REPAIR & NEW MANUFACTURE OF INSTRUMENT
PANEL SHOCK MOUNT BRACKET

PART NO.	734-183B34-B	PART NAME	BRACKET - PANEL SUPPORT
USE OF E.M.	DISPOSITION OF STOCK		
SALVAGE	CHECK CLOCKS AFFECTED	NOT AFFECTED	USE TO REWORK
COMPRESSION			REWORK
STOP ORDER/RELEASE			AS NOTED
NEW DRAWING	PARTS COMPLETED		
REVISED DRAWING	PARTS IN PROCESS		
VARIATION	TOOLING		
OBsolete NOTICE	RAW MATL.		
USE AS NOTED	INTERCHANGEABILITY AFFECTED	YES

ENGINEERING MEMORANDUM

EXTRA CLIP

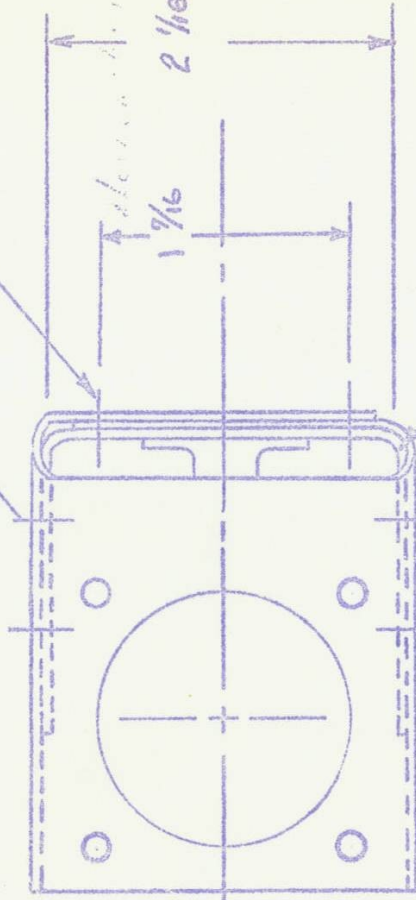
TO PREVENT DEVELOPMENT OF FATIGUE CRACKS
IN INSTRUMENT PANEL SHOCK MOUNT BRACKET 734-183B34-B
FUTURE PRODUCTION ITEMS ARE TO INCORPORATE AN
EXTRA CLIP AS SKETCHED ON PAGE 2

USED BRACKETS WHICH ARE CRACKED IN THE
CORNER INDICATED BY ARROW 'X' MAY BE REPAIRED
AS FOLLOWS PROVIDED THE CRACK IS NO LONGER
THAN 3/16 INCH

- (A) STOP DRILL CRACK
- (B) REMOVE ANCHOR NUT
- (C) INSTALL EXTRA CLIP AS SKETCHED ON PAGE 2
- (D) REPLACE ANCHOR NUT

BRACKETS WITH CRACKS LONGER THAN 3/16
INCH ARE TO BE SCRAPPED

AN 470 AD3 4 REQ

AN426AD3 2 REQ

MATL - 2024 AL.

.064 THICK
